# MERCY OTHELLO PLAZA

DESIGN RECOMMENDATION MEETING - DPD# 3018112

**6940 MLK JR WAY S.**  
AFFORDABLE HOUSING

08.18.2015

# DEPARTURE REQUEST: STREET LEVEL USES - 80% NON RESIDENTIAL USES

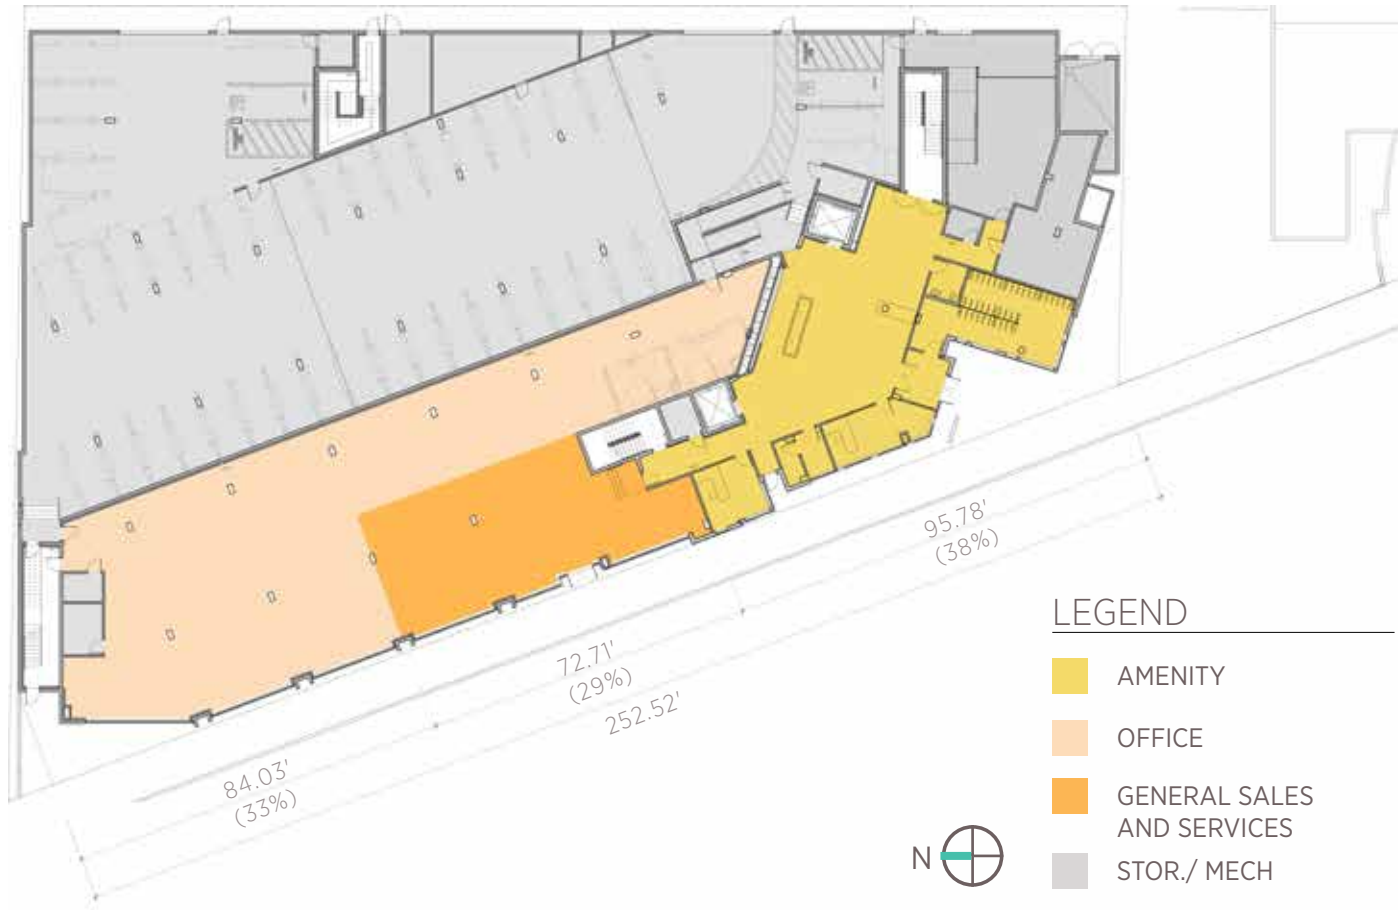
## SMC 23.47A.005.C.1 STREET LEVEL DEVELOPMENT STANDARDS

A minimum of 80% percent of the width of a structure's street-level street-facing facade that faces a principle pedestrian street shall be occupied by uses listed in subsection 23.47A.005.D.1. The remaining 20 percent of the street frontage may contain other permitted uses and/or pedestrian entrances.

## REQUEST

Decreased uses in subsection 23.47A.005.D.1.

Proposed approved pedestrian street uses along ML King Jr Way S: 62.3' (29%)

- The Board was receptive to office uses provided the space is convertible to retail in the future.
- Streetfront facade designed to meet the intent of the guideline, including using traditional retail bays to create transparency
- Eyes on the street for a safe and active street front.
- Landscaping and weather protection provide welcoming pedestrian experience.

# DEPARTURE REQUEST: NON-RESIDENTIAL DEPTH

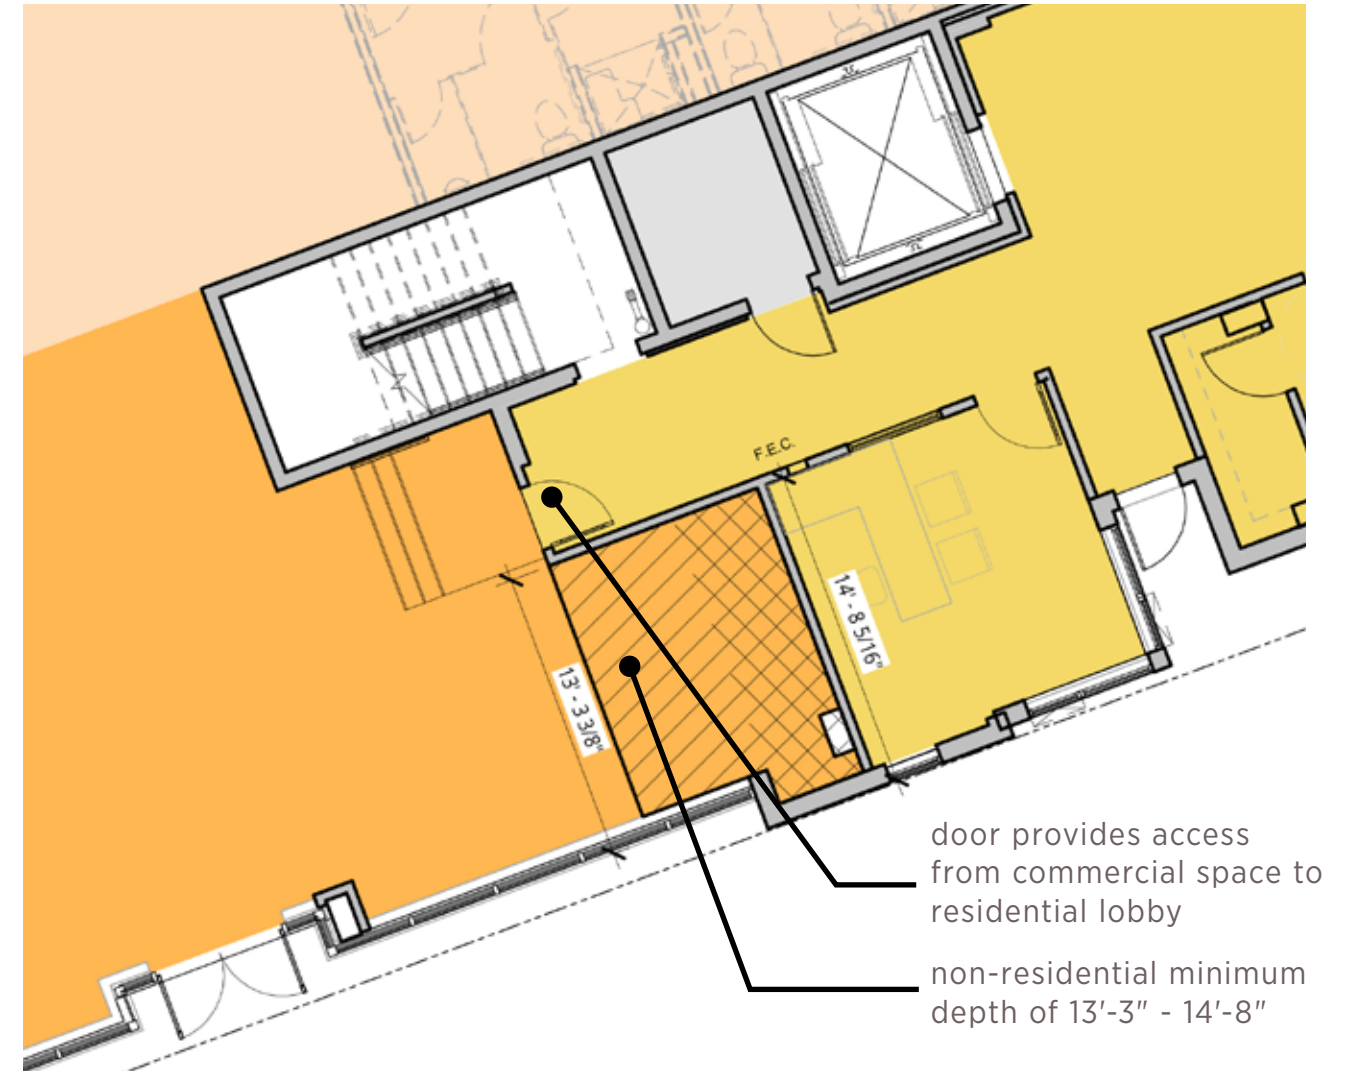
## SMC 23.47.A.008.B.3 STREET LEVEL DEVELOPMENT STANDARDS

Height and depth provisions for new structures or new additions to existing structures. Non-residential uses shall extend an average of 30' and a minimum of 15' from the street-level street-facing facade.

## REQUEST

Decreased minimum depth requirement.

Proposed minimum depth of 13'-6" along a 10.16' portion of the street-level street-facing facade.

- Departure along 4% (10'-4") of the MLK facade
- Proposal meets 30' average depth requirements
- Access between spaces provides flexibility over time

# DEPARTURE REQUEST: LANDSCAPE SETBACK

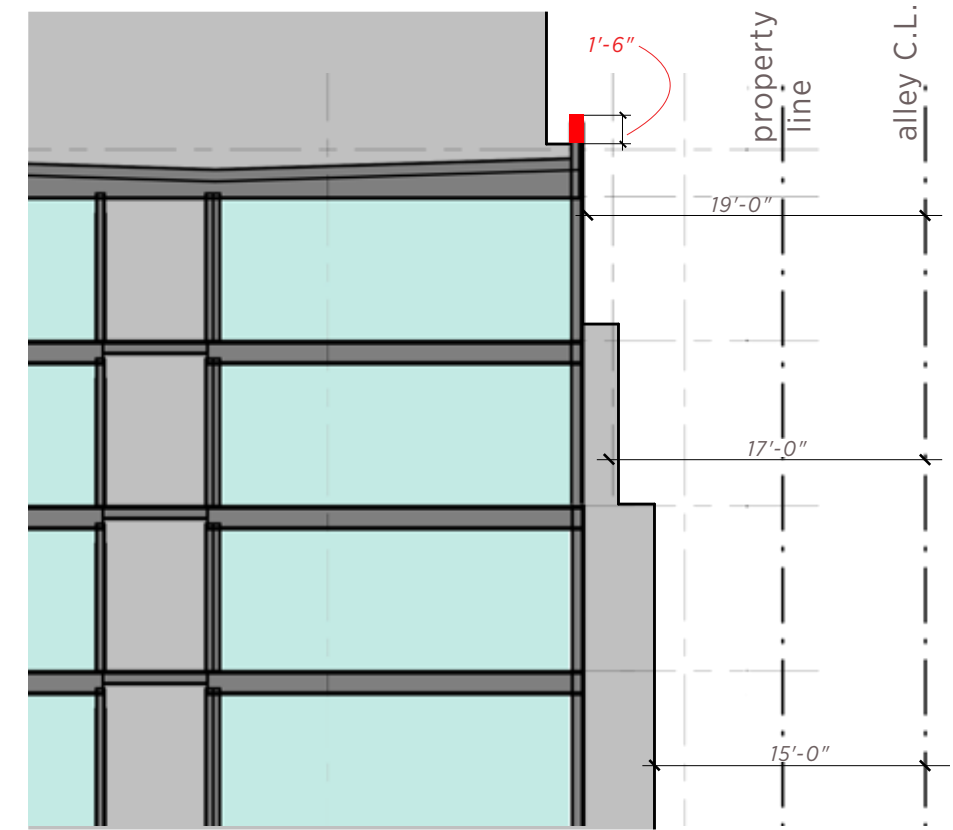
When a parking garage is 8 feet or more above grade, a 3.5 foot screening along the perimeter of each floor of parking is required.

## REQUEST

Decreased landscape setback along the north property line.

The proposal requests that the required landscape setback not be required along the north edge of the parking garage.

- Setback creates maintenance and safety issues
- Zero lot line
- Further development would inhibit landscape viability
- North facade not visible to pedestrians
- Landscape setbacks provided along alley to improve pedestrian experience
